Video Products Technical Bulletin 30-2006-003

SUBJECT: REUSE IC306 WHEN REPLACING A BOARD

MODEL: PVM-1340/M
PVM-1341
PVM-1342Q
PVM-1343MD
PVM-1440QM
PVM-1442QM
PVM-1443MD
PVM-1444QM

Figure 1

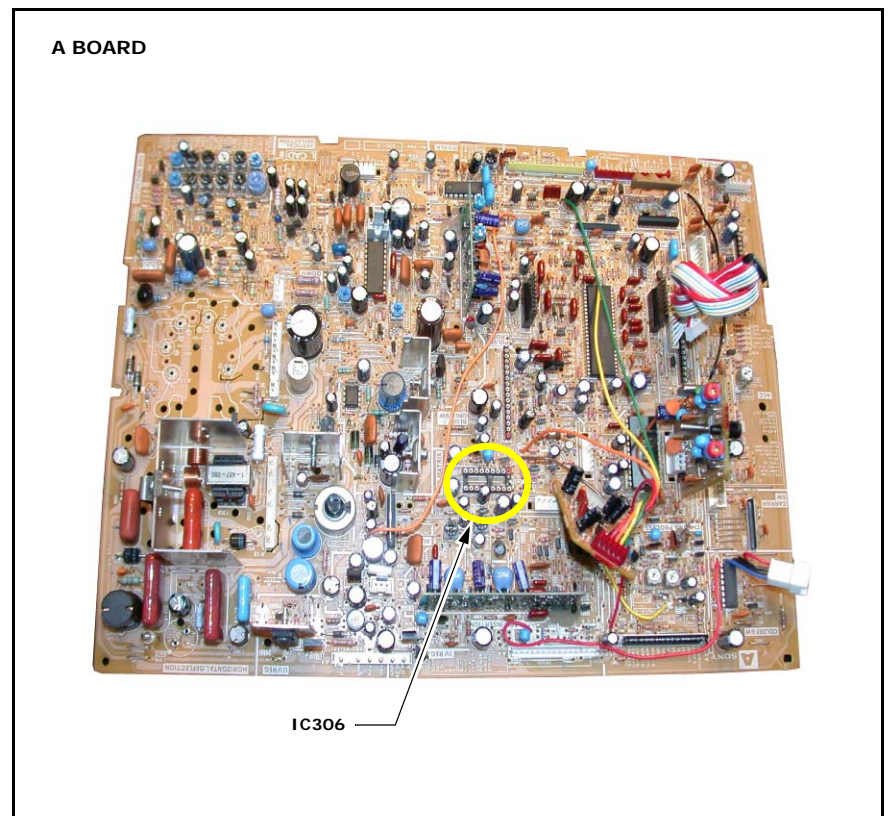
The new A board does not contain IC306, and IC306 is no longer available as a service part. (See Figure 1.)

When you replace the A board (A-1296-520-D), remove IC306 (8-759-421-16, IC AN5614) from the former board and install it on the new board.
